**RE: Grade II\*-listed former Anglican Church of Christ Church Albany Street / St George's Cathedral, 1-3 Redhill Street, London NW1**

ENC  
Conisbee Mark-up Drawings: SK-01, SK-02 and SK-03

CONISBEE MARK-UP  
 200468-S-SK-01 29/01/2021

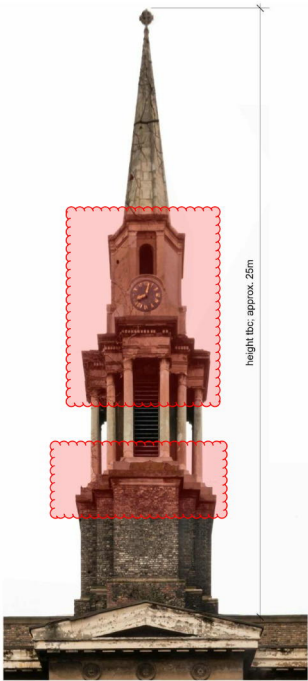
DENOTES AREA OF PROPOSED NETTING TO PREVENT AND RESTRAIN DEBRIS FALLING.  
 NETTING TO BE HUCK 45mm Mesh Fall Arrest Net with Debris Overlay & Border Rope (PRODUCT ID: 1903D-045) STRAPPED  
 TIGHT AND SECURED TO BRICKWORK WITH EXCALIBUR M8 SCREWBOLTS M8 EYB 06 / 050 AT MAX 500mm ctrs.  
 Dry fix into pre-drilled holes located centrally through bricks to manufacturer recommendations.
